This Service Information bulletin supersedes SI B12 18 14 **dated March 2015**.

### Engine Misfire Due to Failed Ignition Coil

With the N51, **NEW** N52\*, N52K, and N52T engines

### Ignition Coil Identification

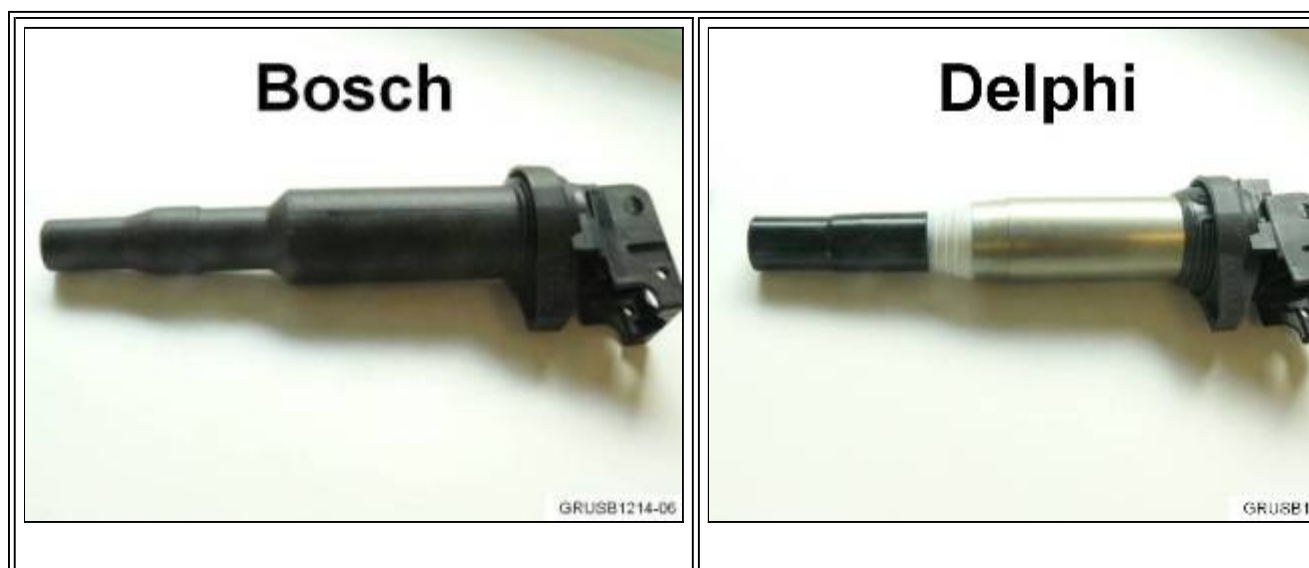
1. **NEW** For vehicles with the **N51, N52 (from 4/2006), and N52K** engines which have been in service for over 24 months or 10,000 miles: during the first service visit due to an ignition coil failure, replace **all Bosch** ignition coils with **Delphi** coils as indicated in ETK (March 2015).

If any ignition coil(s) was replaced previously with a **Delphi** part, it does **NOT** need to be replaced.

2. For the F10 and F25 with the **N52T** engine, replace **all Bosch** ignition coils with the replacement **Delphi** coils under these situations:
  - At the first service visit with for an ignition coil failure
  - Alternator failure (see [SI B12 12 13](#))
  - DME replacement due to a failed Bit Serial Data (BSD) interface circuit

Part Number	Description	Quantity
12 13 8 616 153	Delphi coil	Up to 6
